Reliability Analysis Update PJM West

Jeffrey Goldberg, Brian Hau
Sub Regional RTEP Committee – PJM West

February 13, 2026

Cancellations

Avon 138 kV Breakers "4-B-107 and 4-B-84" Replacement

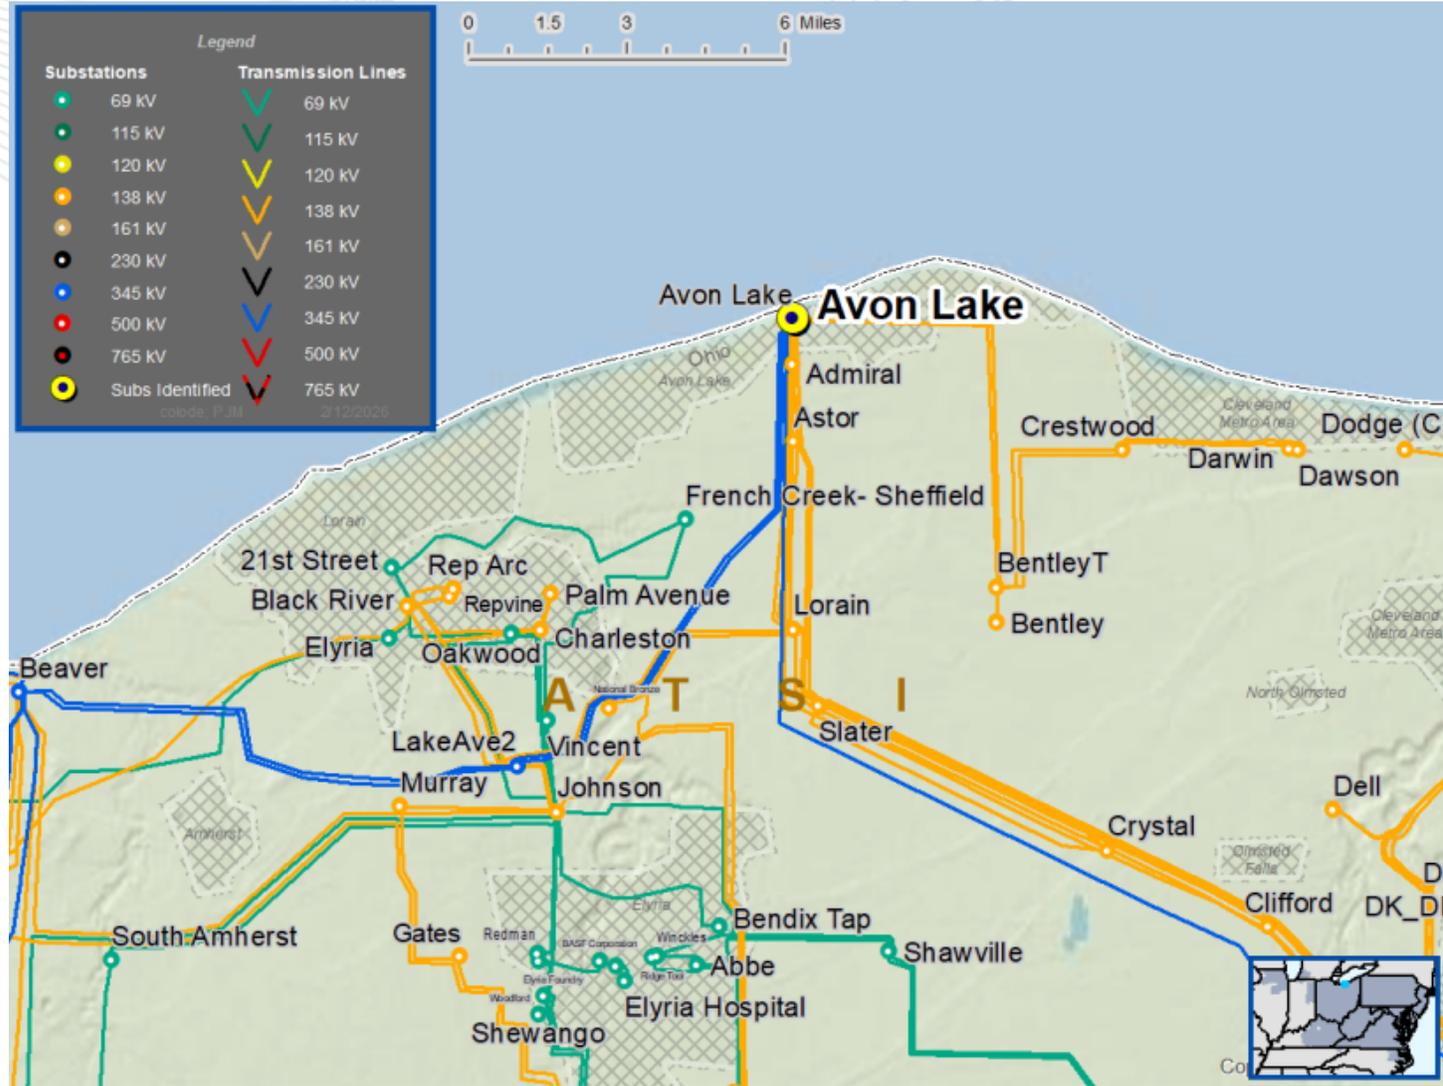
Cancellation of b3985.1

Original Proposed Scope:

Replace the 2 overdutied Avon 138 kV circuit breakers "4-B-107 and 4-B-84" with 63 kVA circuit breakers.

Reason for Cancellation:

Breakers are Distribution assets, not Transmission.

Breakers are not controlled by PJM

ATSI Transmission Zone: Baseline Johnson 69 kV Breaker "451-B-163" Replacement

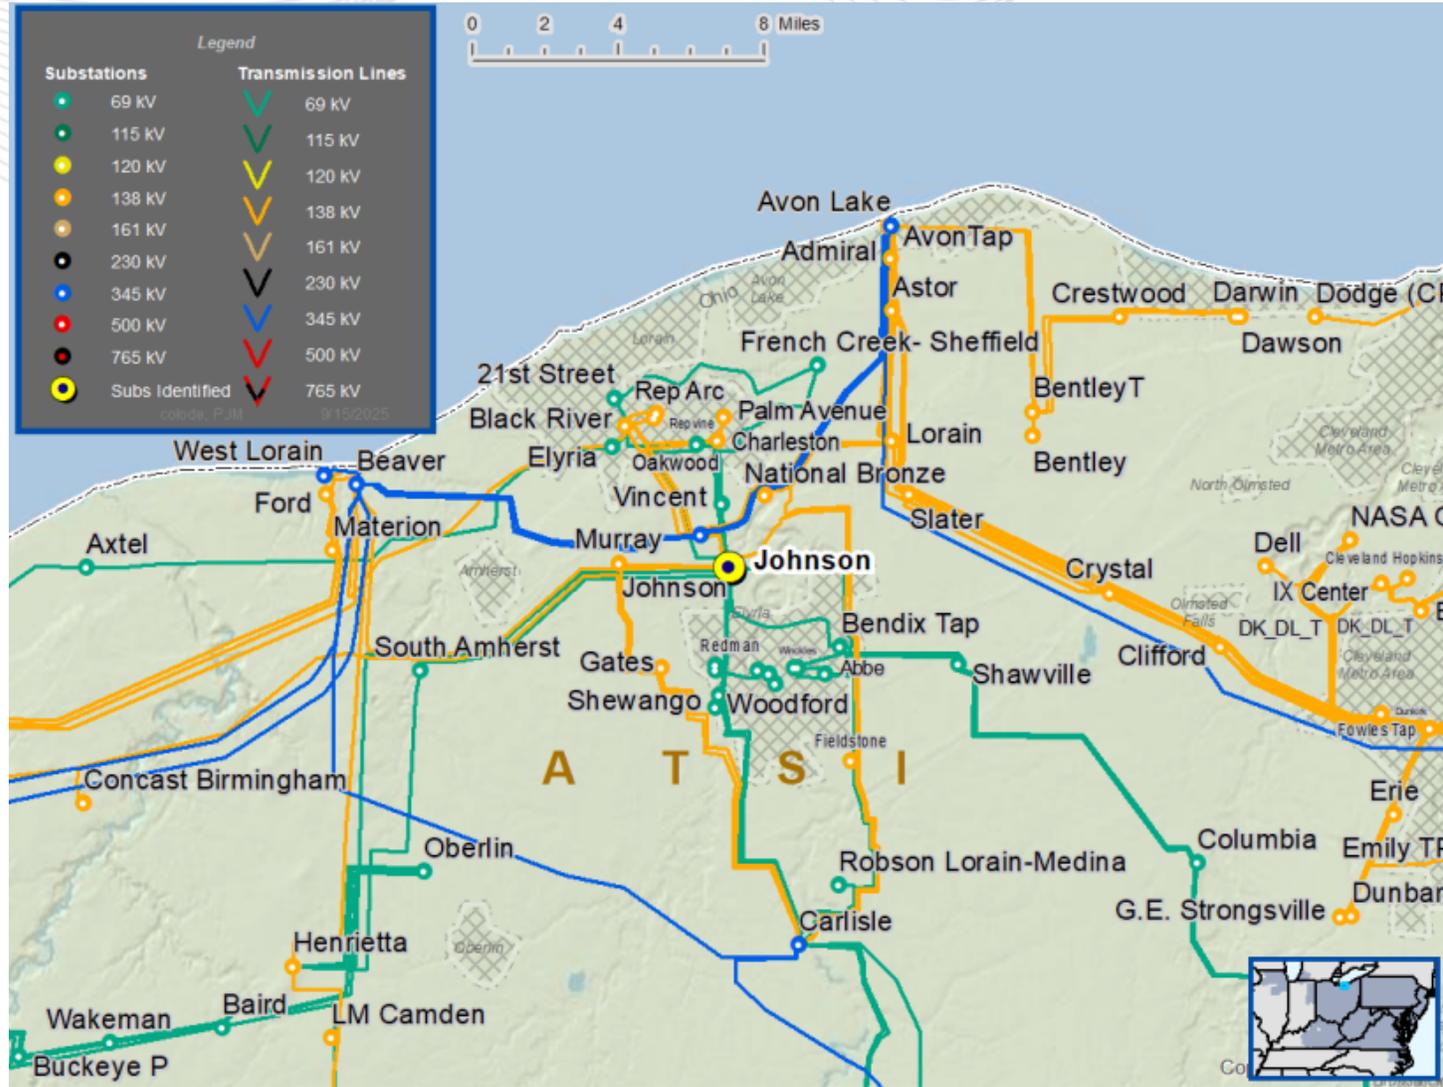
Cancellation of b3985.4

Original Proposed Scope:

Replace the overdutied Johnson 69 kV circuit breakers "451-B-163" with a 63 kA circuit breaker.

Reason for Cancellation:

The breaker was recently replaced this fall due to a failure. It was replaced with a 40 kA breaker. It is no longer overdutied.
